# Value Planning Report

## Plan Formulation Project South Utah & Juab County, UT

Workshop Dates: June 24-28, 2024  
Report Date: October 29, 2024

Final  
Value Engineering Study Report  
for

Alternative No.: RL-03

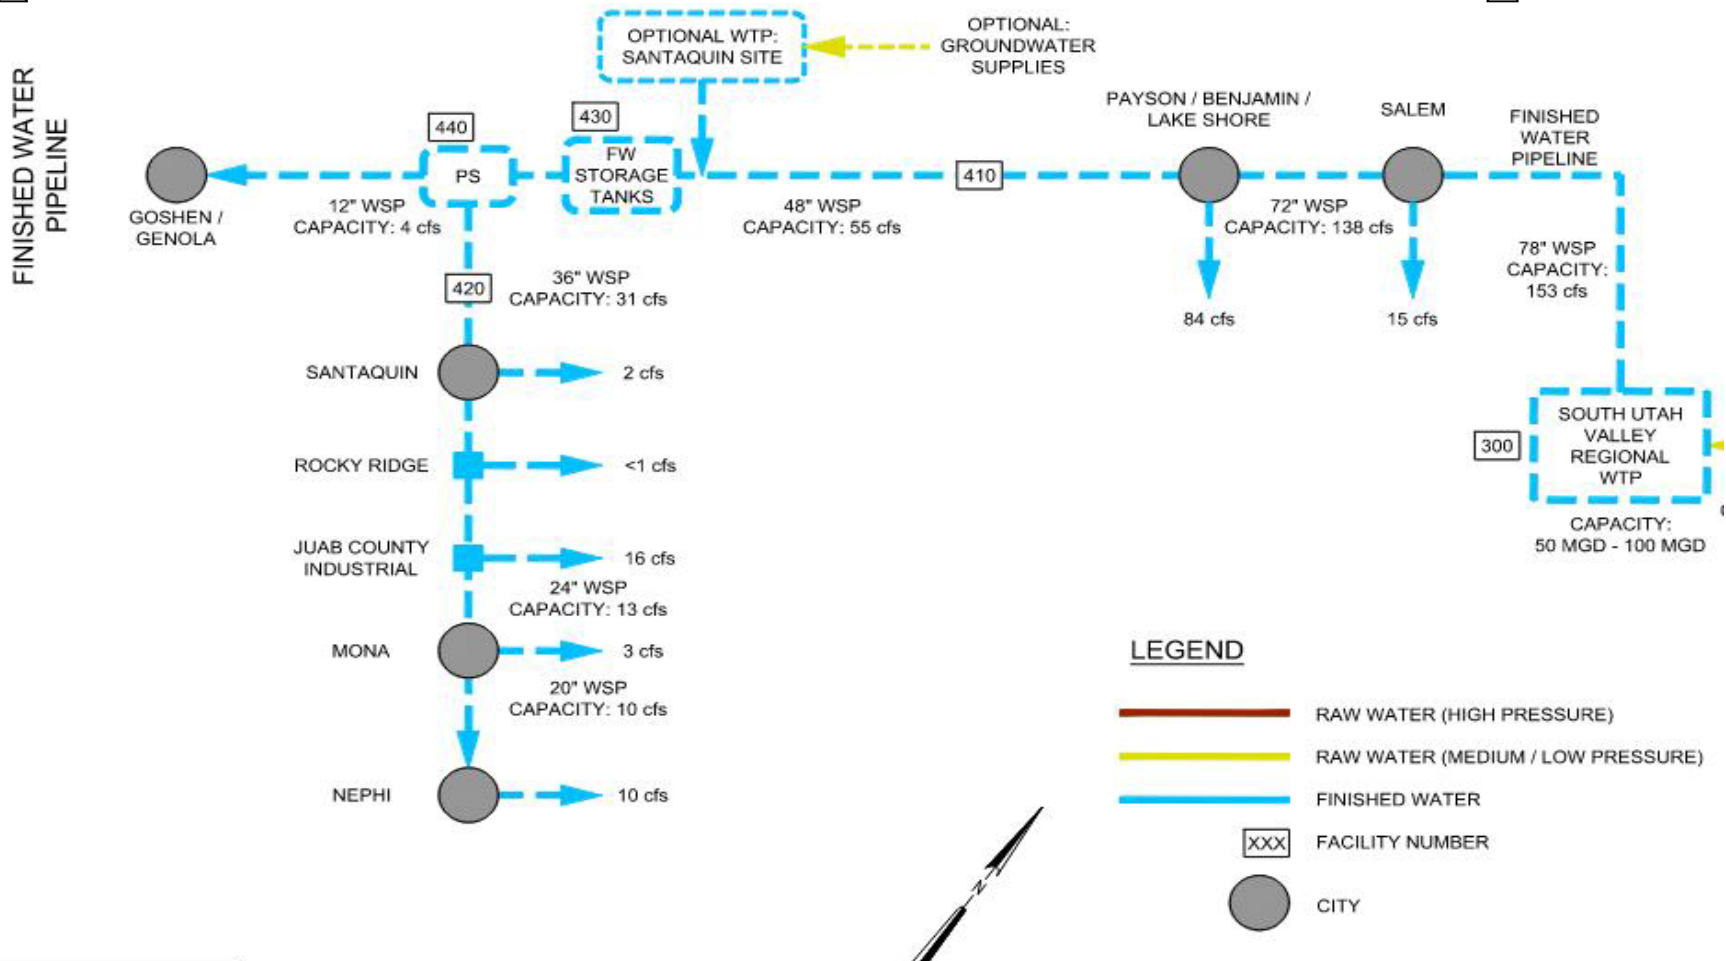
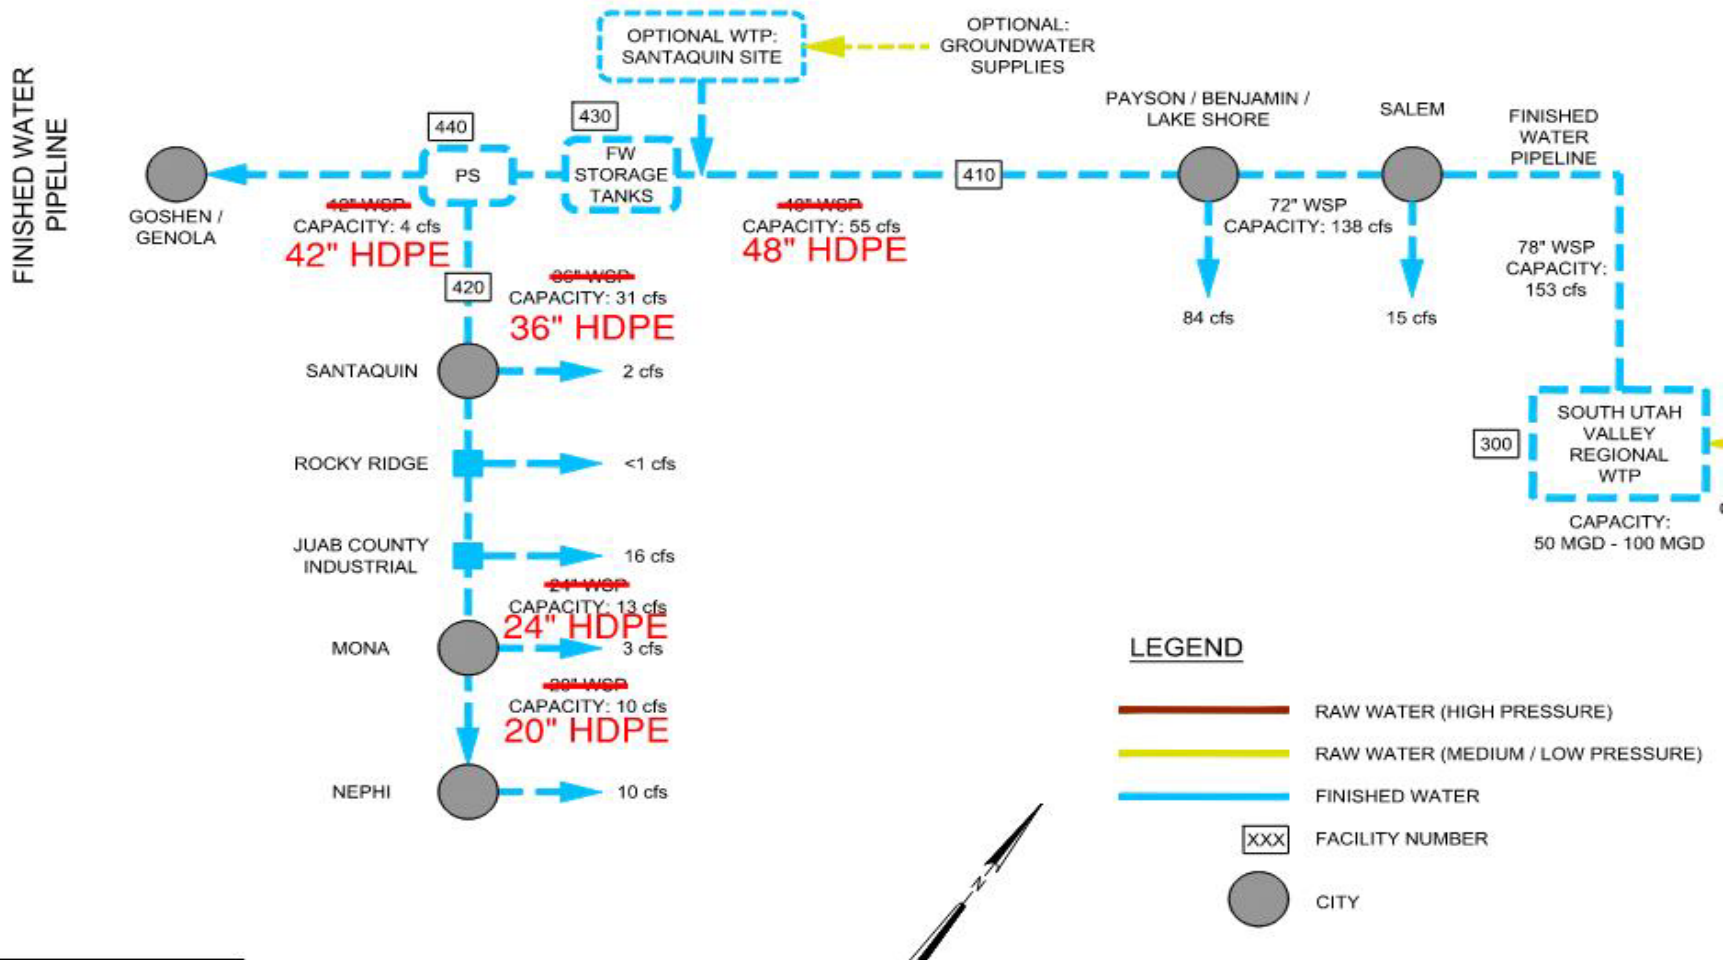
At this stage of the design, the implementation of this alternative concept would be to allow the use of HDPE and provide a bid alternative to the WSP. The District then makes the final decision on welded steel pipe versus HDPE based on cost savings. Connection details have not been developed yet. These would need to be developed in subsequent phases of the project.

Alternative No.: RL-25

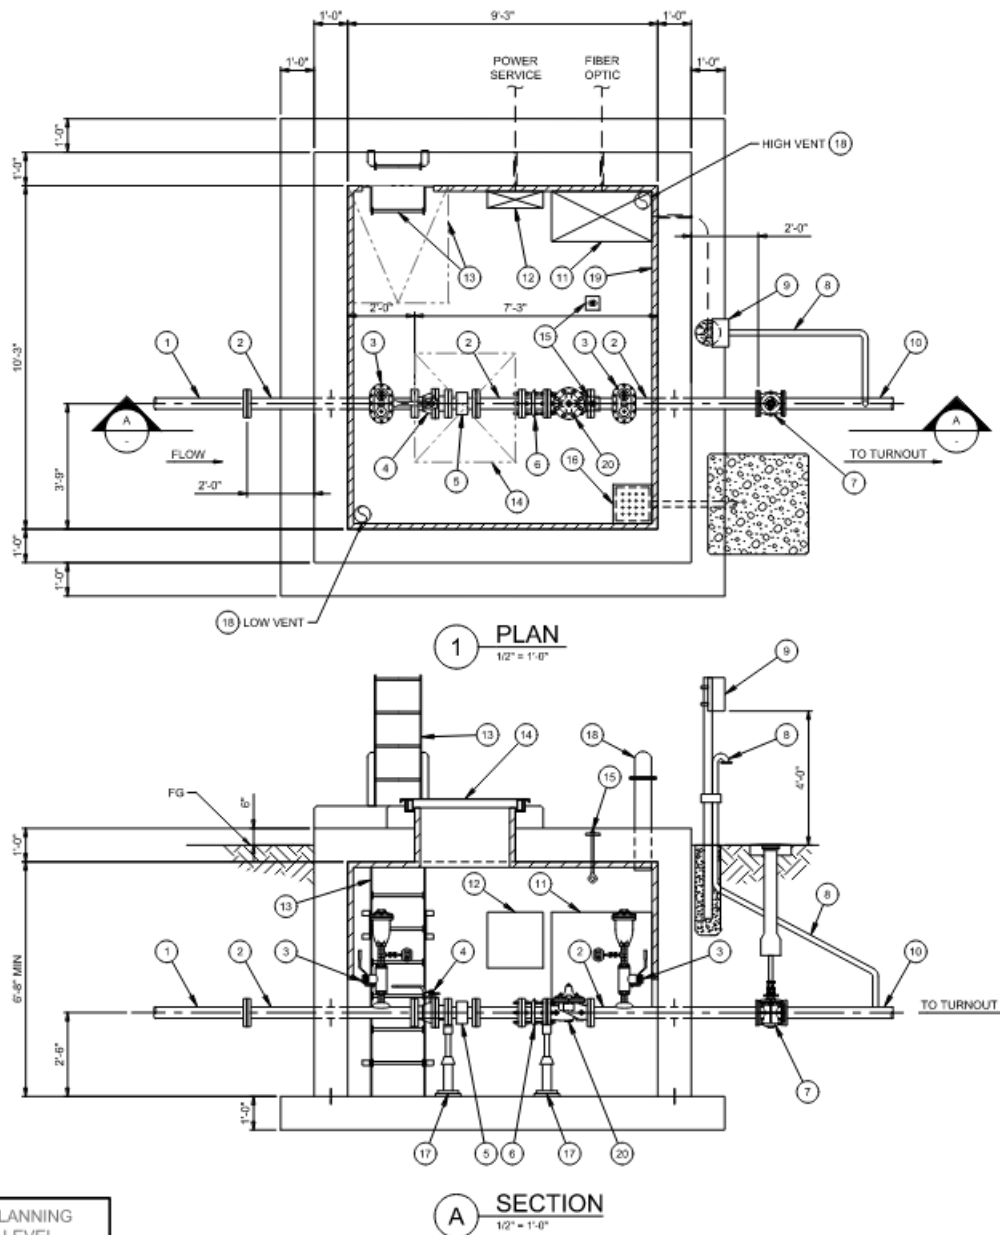
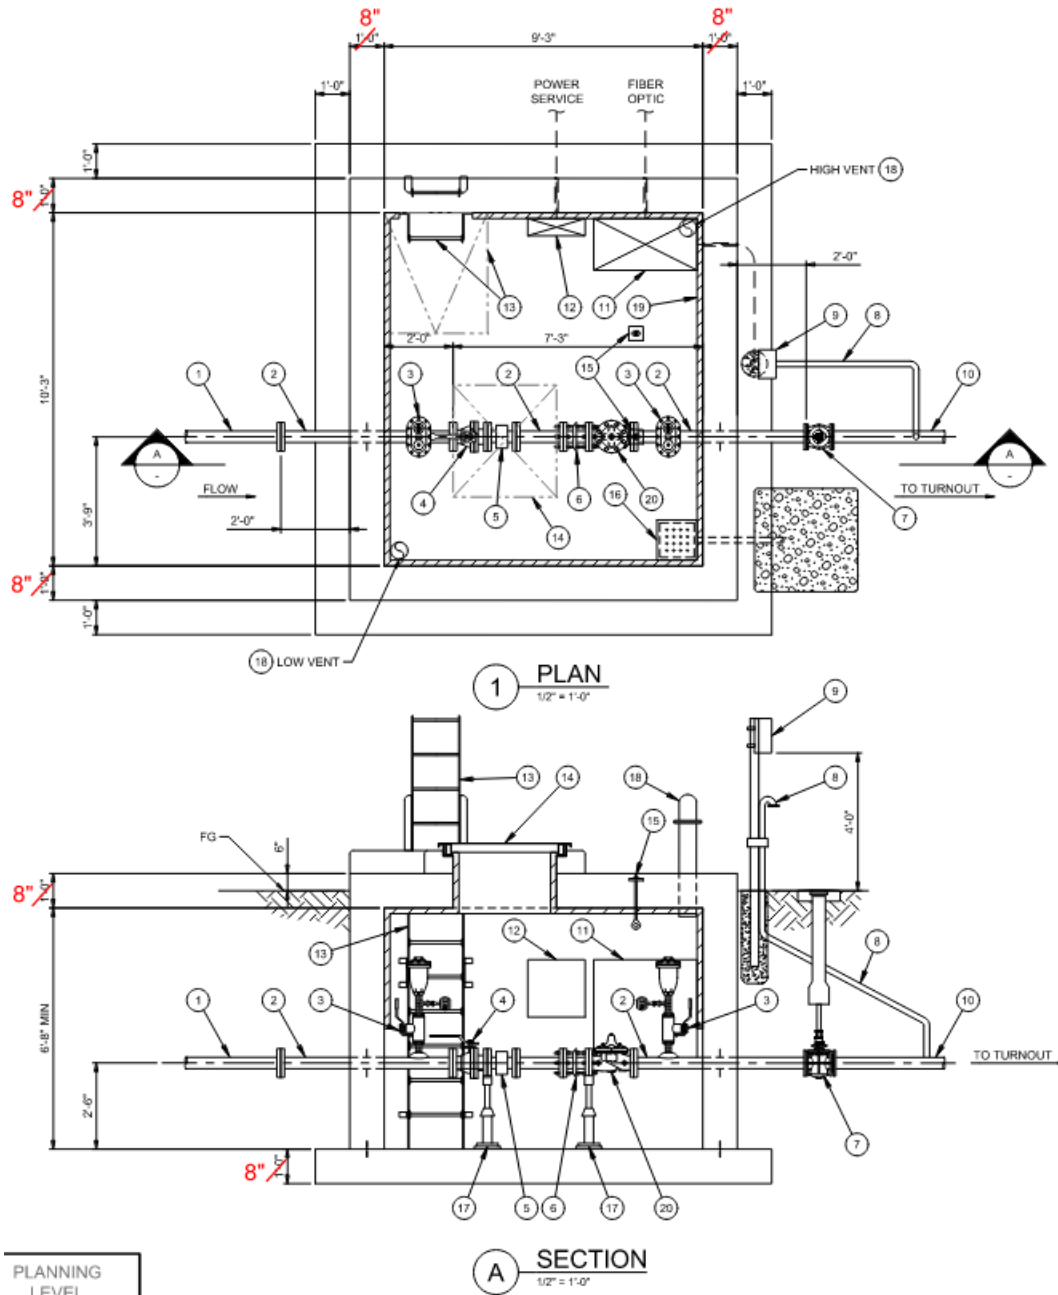
RL-11	
Use earthquake resistant ductile iron pipe at select fault zones .....	5-79
RL-25	
Use 8-inch thick concrete walls and slabs for turnouts along Strawberry Highline Canal .....	5-89
RL-28	
Use select backfill in lieu of trench zone controlled low strength material.....	5-95
RL-33	
Replace the isolation ball valves with butterfly valves .....	5-103

Vaults of this depth are routinely less than 12 inches thick.

Alternative No.: AT-01

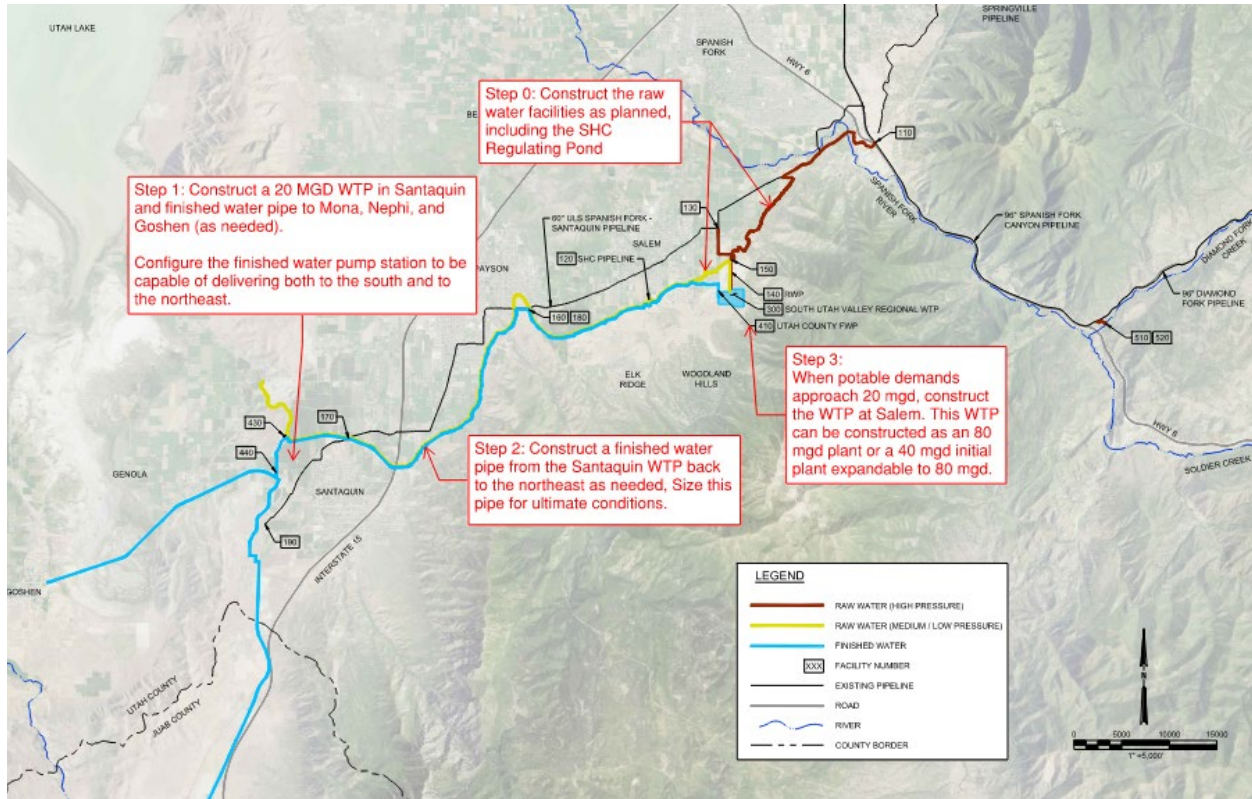
AT-01  
Construct a 20 MGD water treatment plant at Santaquin first to serve the downstream (Juab County) demand and construct an 80 MGD South Utah Valley Regional Water Treatment Plant in the future 6-11

1. Confirm demands to ensure that upstream communities' needs will be met without the Salem WTP in the short-term.
2. Prepare a conceptual design of a 20 MGD facility in Santaquin and 80 MGD facility in Salem.
3. Anticipate the addition of a second operational team to service the new 80 MGD facility.

Alternative No.: MC-03

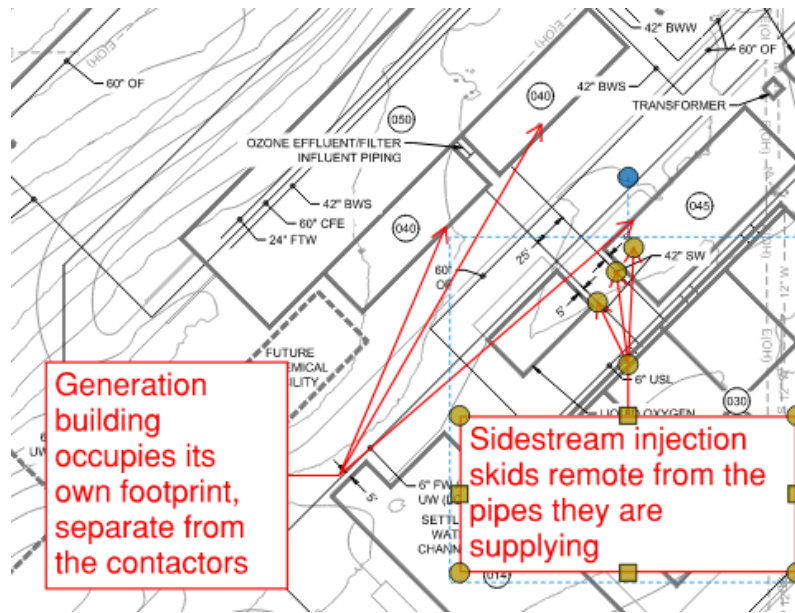
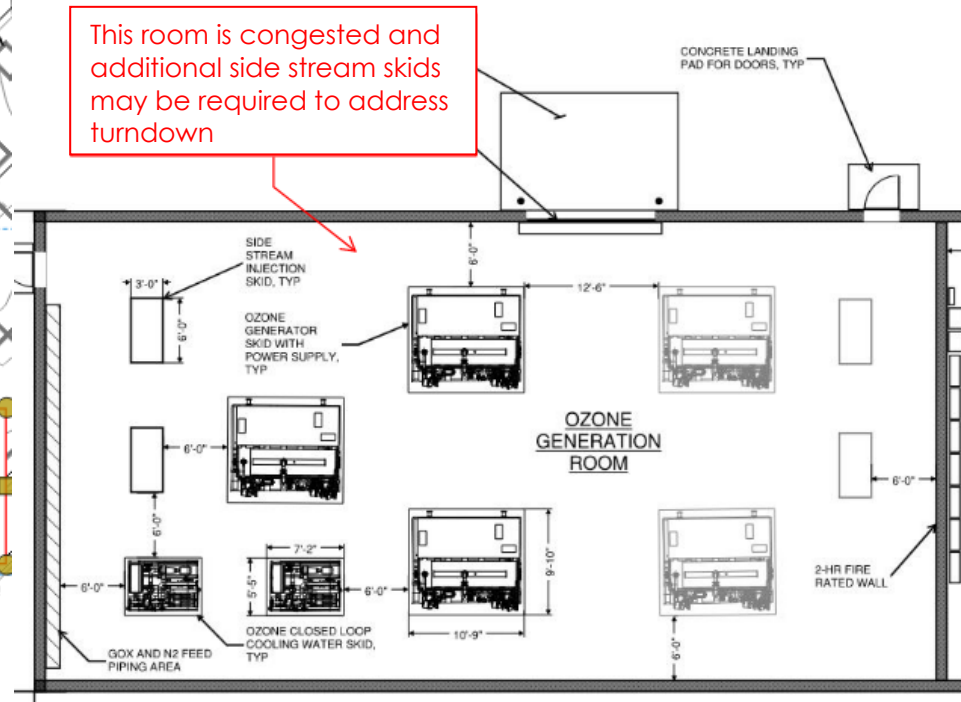
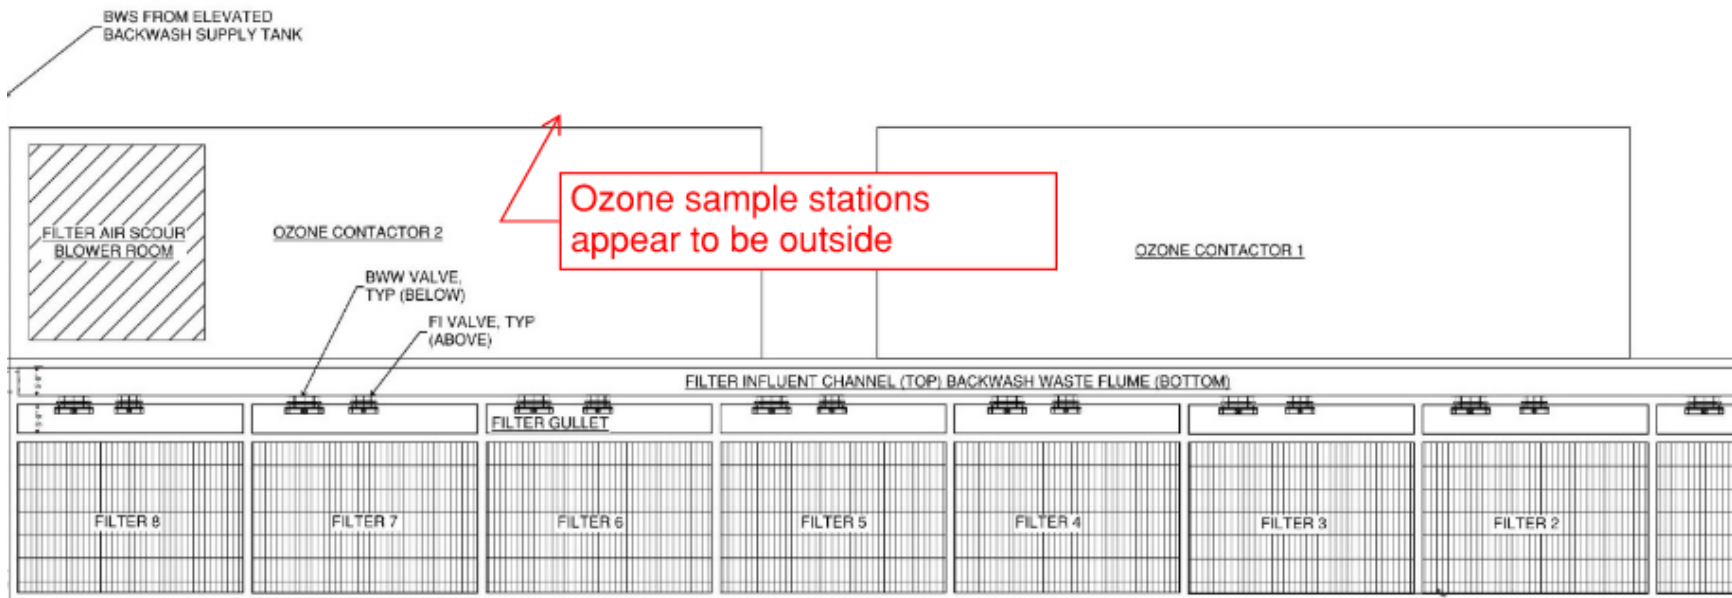
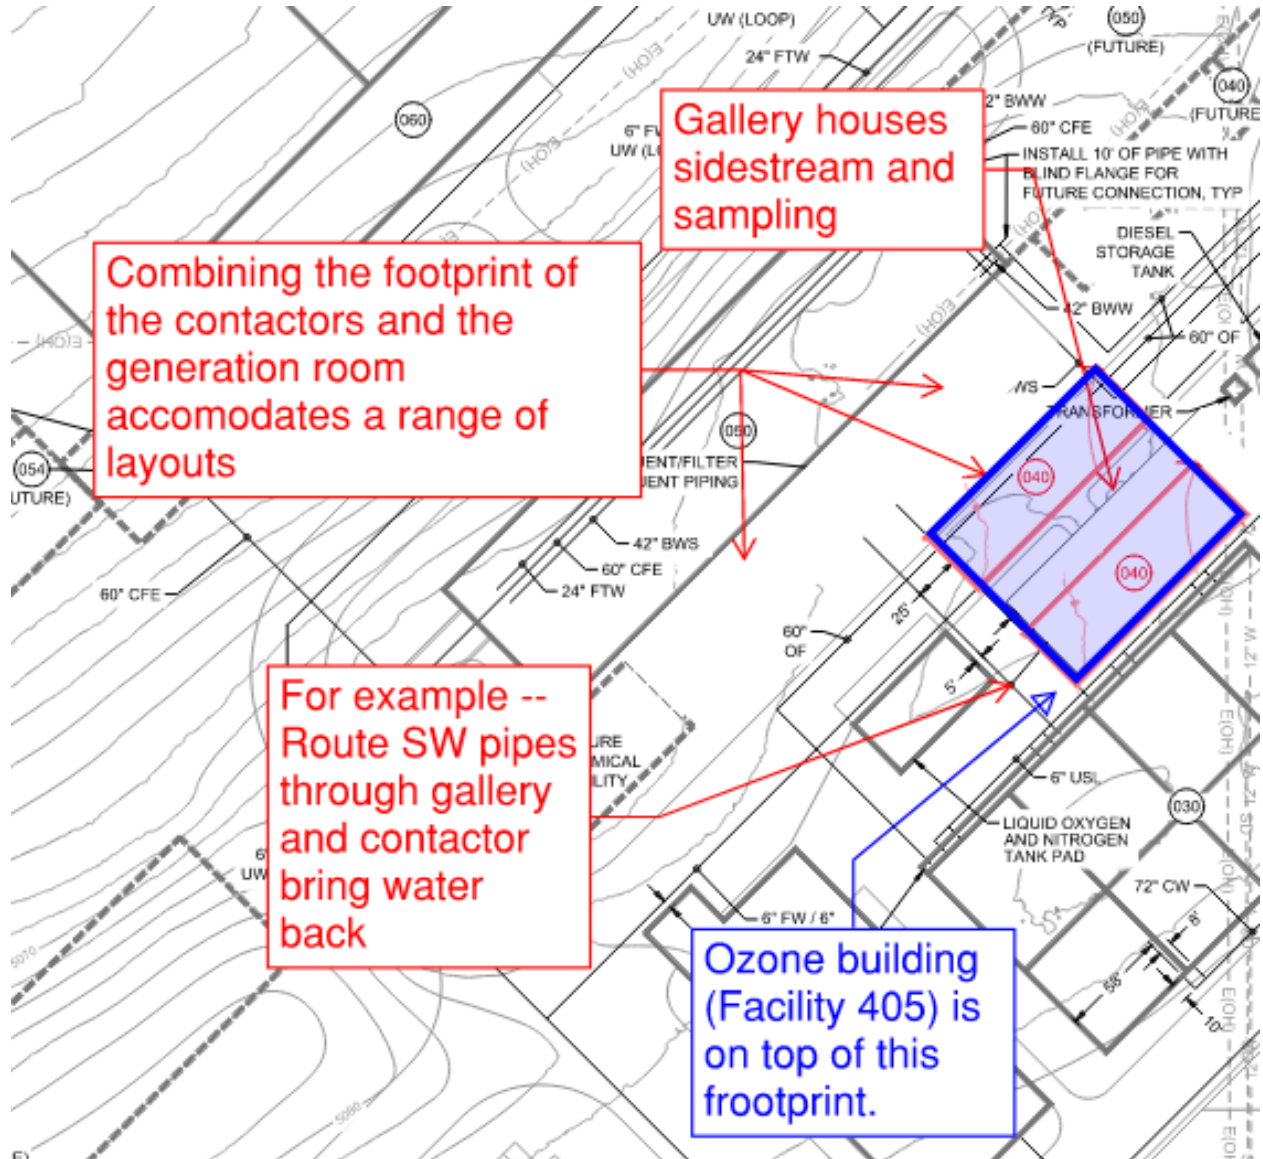
This can be implemented as part of the normal course of design. Particular attention is required to coordinate contactor deck openings, structural supports, and floor drains with the gallery and contactors below.

This room is congested and additional side stream skids may be required to address turnaround
